Review of Kimley-Horn Sediment Transport Model of the Agua Fria River

Prepared for:
Flood Control District of Maricopa County

WEST Consultants, Inc
2151 East Broadway Road, Suite 116
Tempe, AZ 85282

January 10, 2002

RS = 30.73

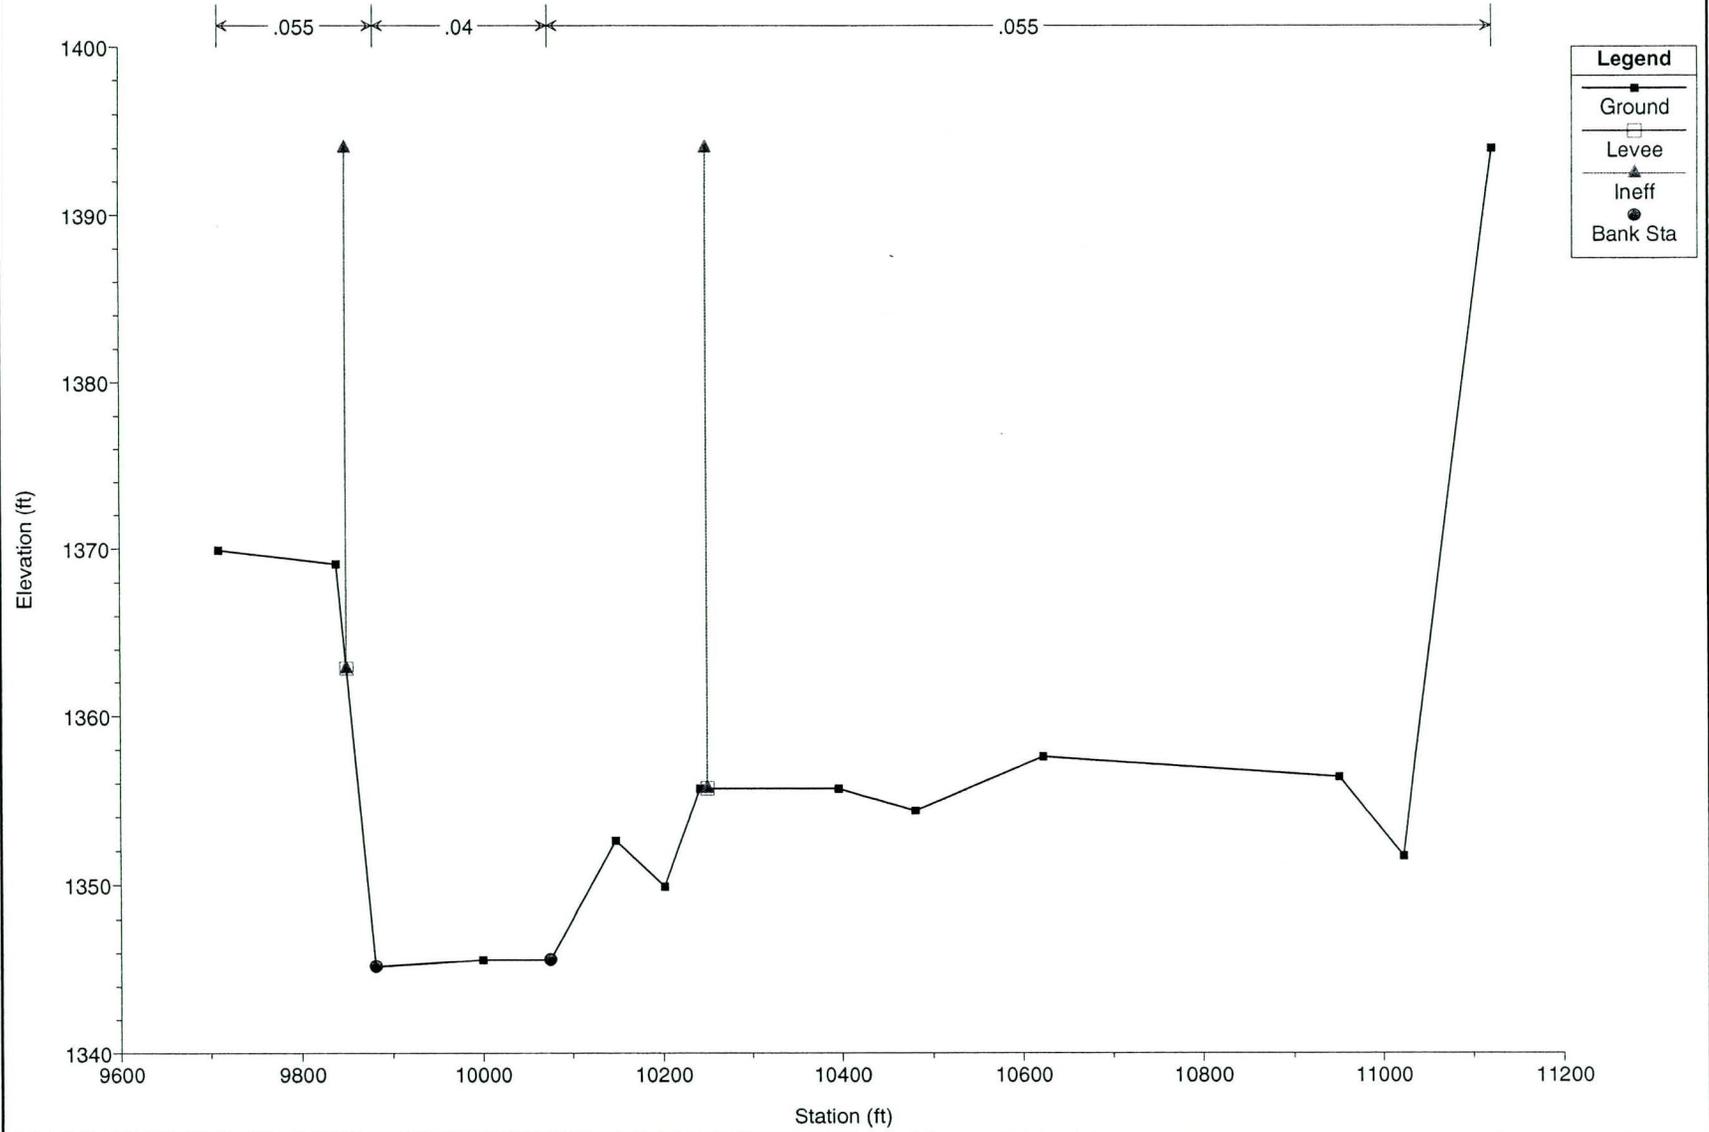
cross sections be introduced at other locations where an abrupt change in velocity occurs (e.g. cross section 32.998, 30.73, 30.07, 17.638, 15.374, 11.428, etc.).

Geom: Existing conditions with movable bed limits as levees
RS = 28.67

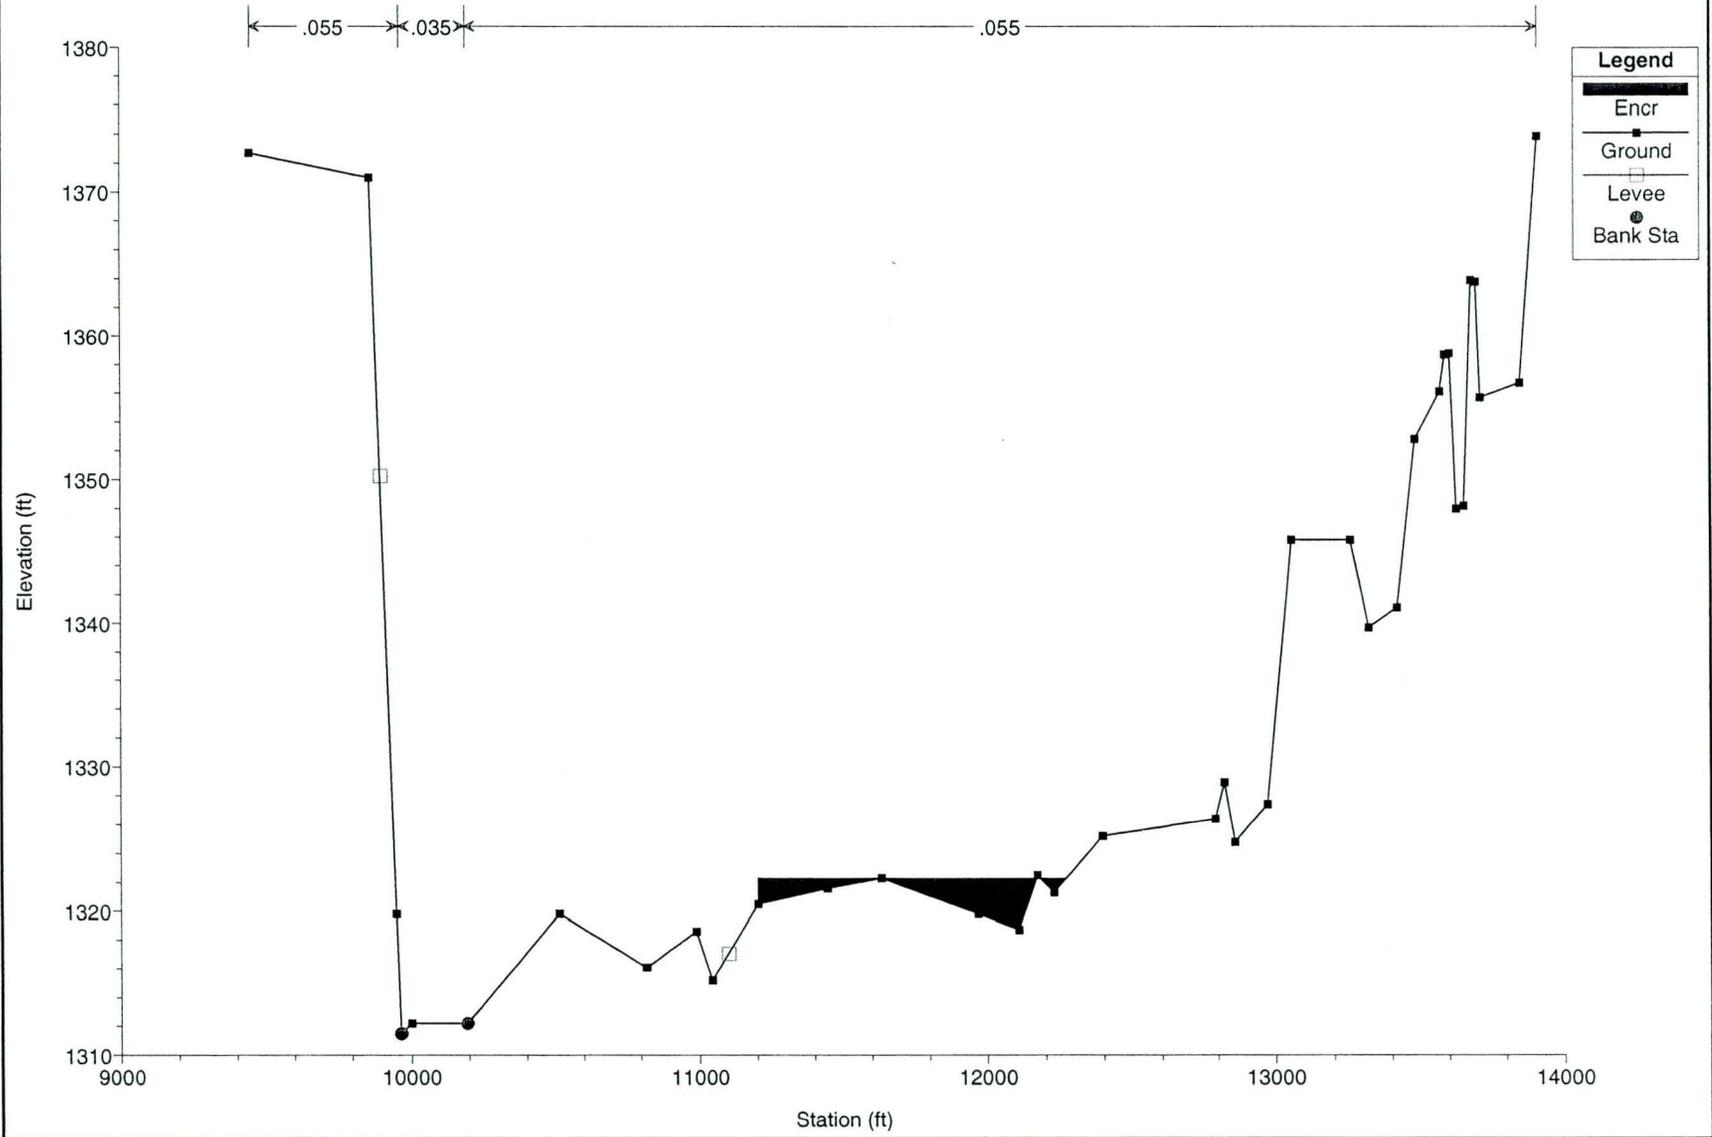
At certain cross sections, the bank stations were specified at the channel bottom: e.g. 28.12 (Figure 7), 28.67 (Figure 8), etc. X3 records (with 10 in the first field), used to confine the flow to the channel until the water surface exceeds the bank elevations, are not functional for such cross sections.

RS = 25.666

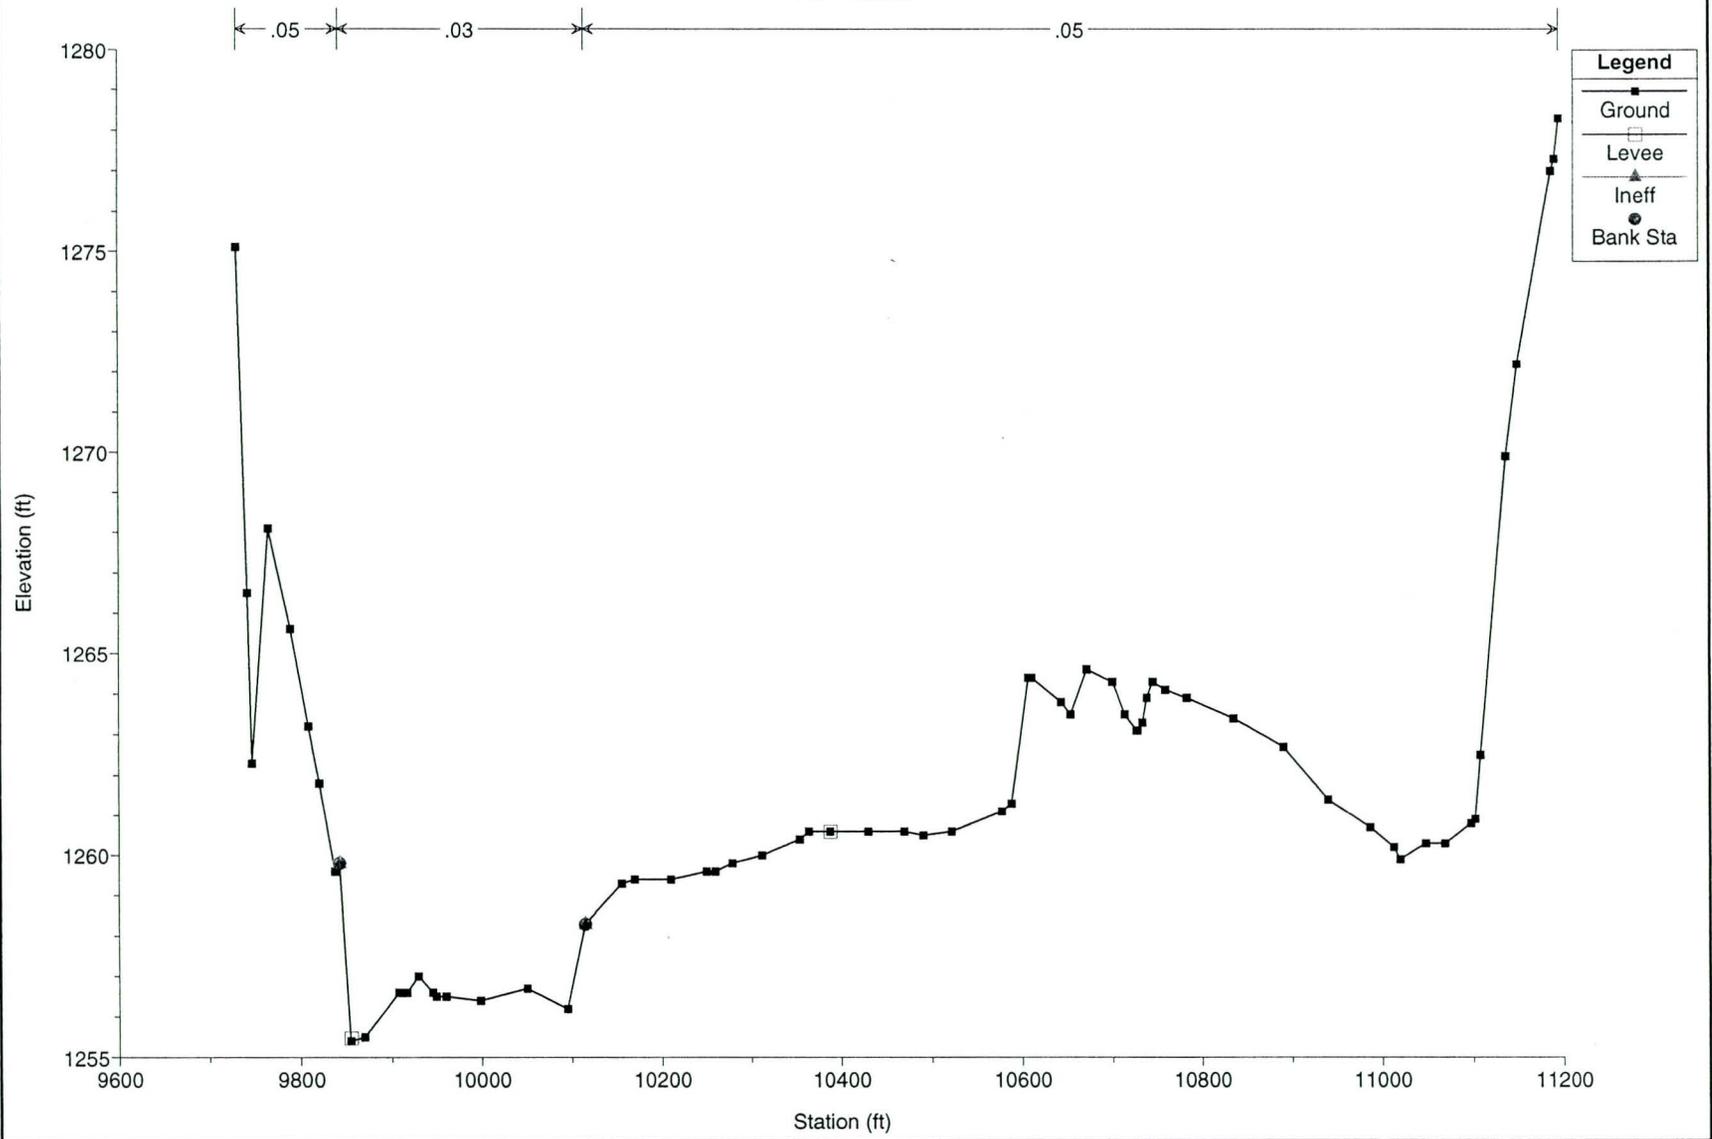
Significant expansion and contraction of the water surface width was noted at several cross sections (e.g. 1.33, 3.43, 15.374, 25.666, 32.92 as well as others). The expansion ratio should generally be limited to 3:1 (3 streamwise units to 1 lateral unit) and the contraction ratio should generally be limited to 1:1 by setting ineffective flow or conveyance limits (X3 or XL records) where appropriate. The cross sections listed above appear to be in violation of these recommendations.

RS = 23.974

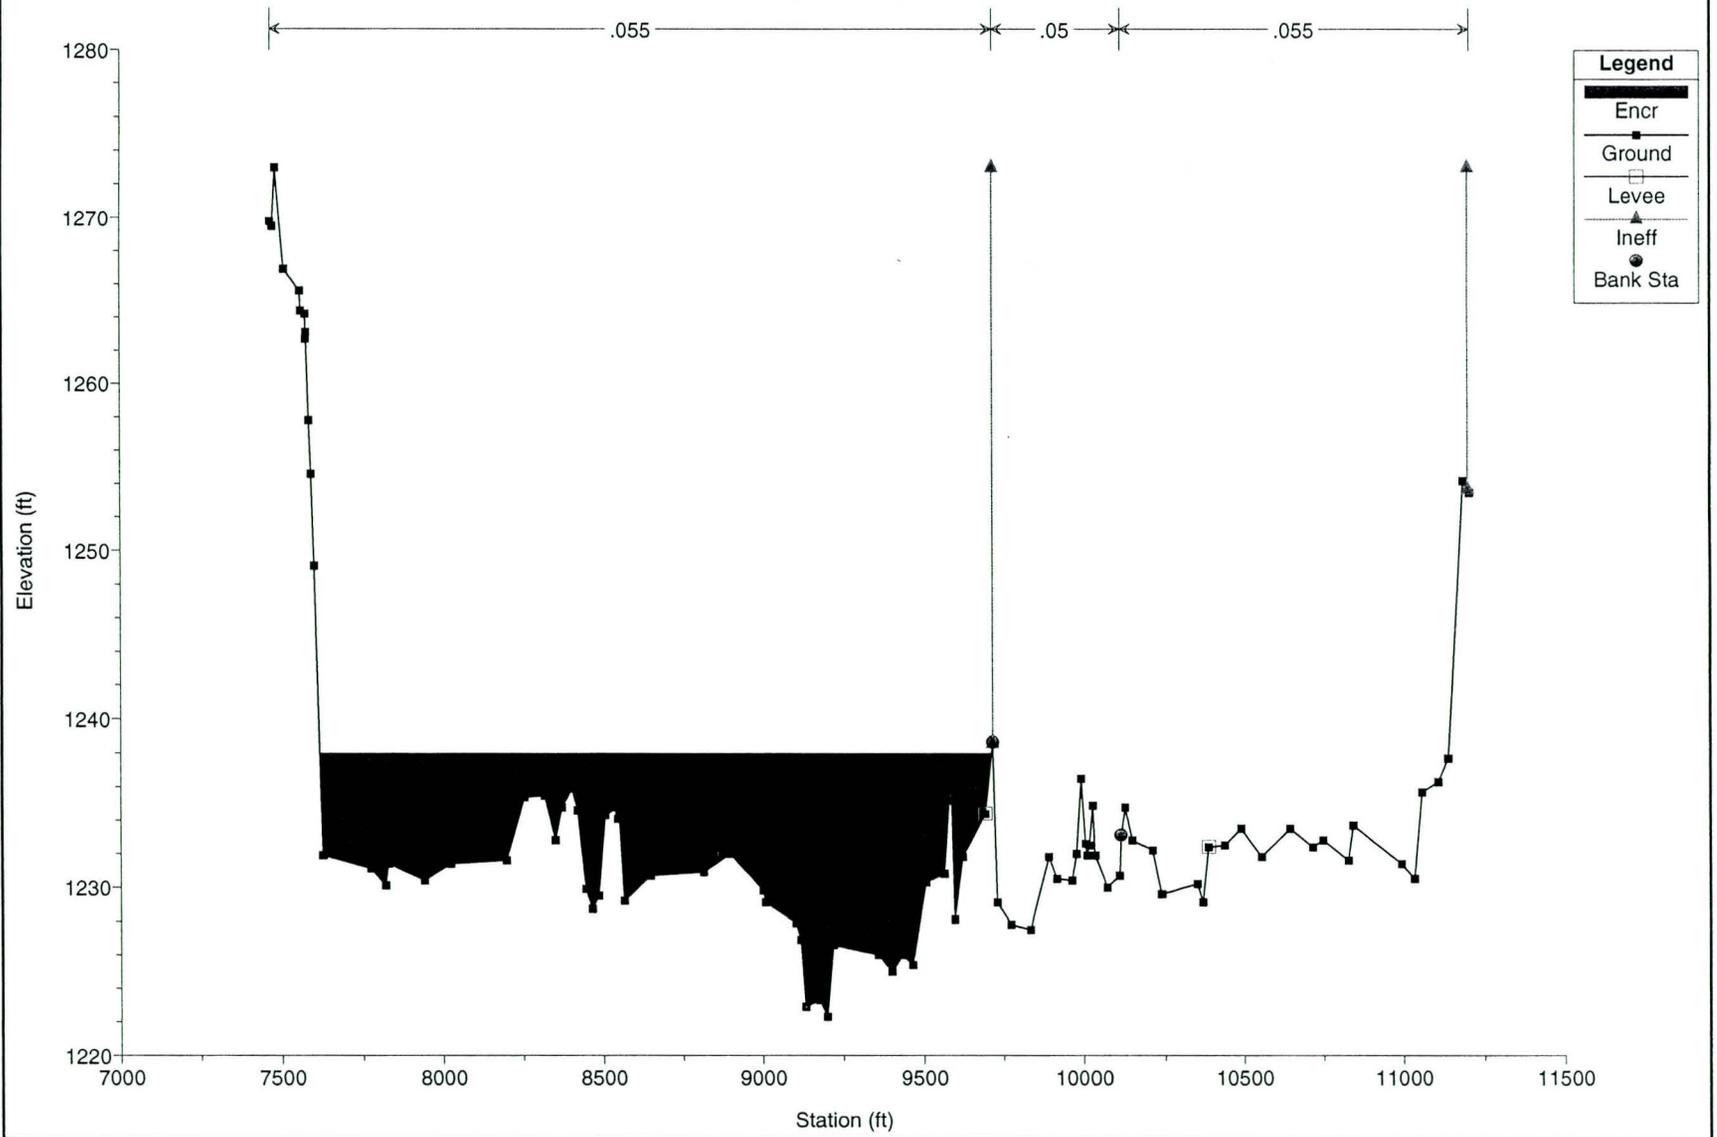
The Manning roughness coefficient in the channel ranges from 0.03 to 0.05. At several cross sections (e.g. 21.157, 21.431, 23.974, etc.) there is a sudden change in the channel roughness (from 0.035 to 0.05) but these values appear reasonable in light of areas with much denser vegetation in some areas of the channel and overbanks.

RS = 21.061

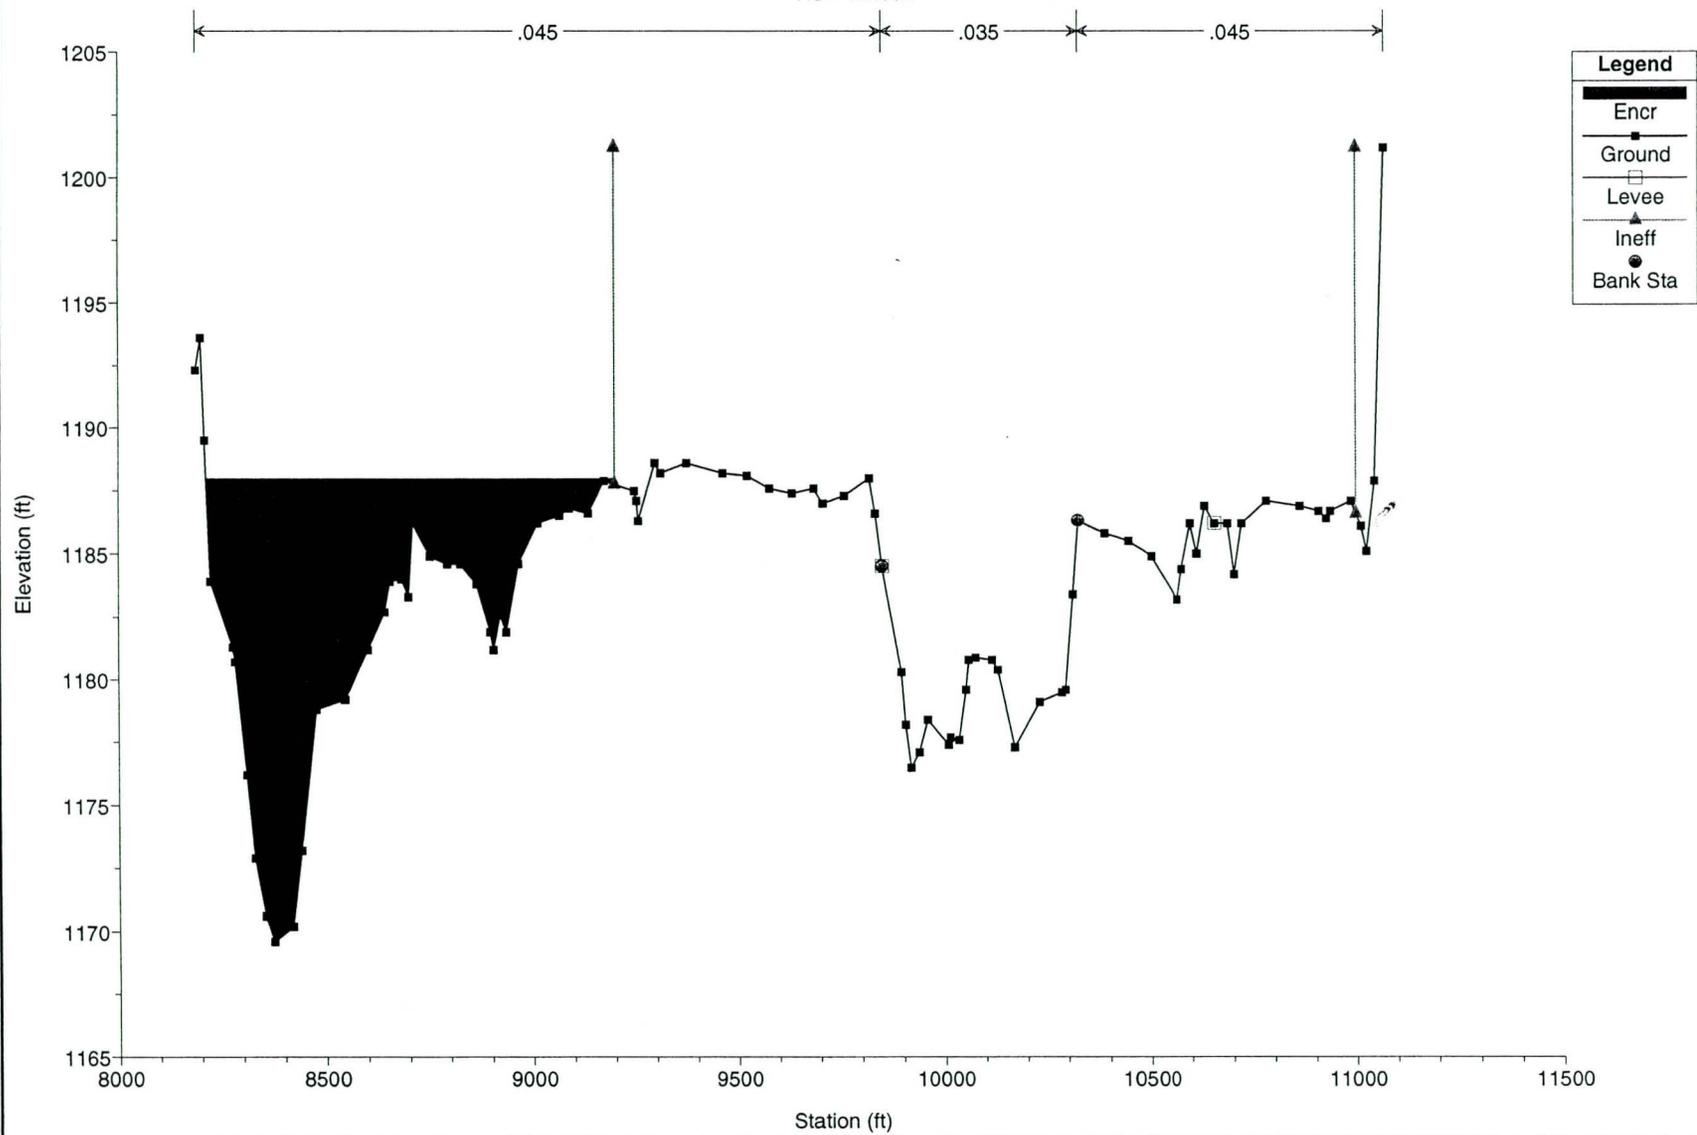
It was noted that some of the encroachment limits specified on X3 records were different from those used in the fixed bed model (e.g. cross sections 0.63, 21.061, etc.). These changes cause a difference in the hydraulic results between the two models. The modeler should verify that the changes were within acceptable limits. Also, for a few encroachment limits the decimal point was missing (compared to the limits used in the fixed bed model), thus increasing the stationing by an order of magnitude (cross sections 8.198, 14.430 in this model but not in the fixed bed model). These inconsistencies need to be checked and eliminated.
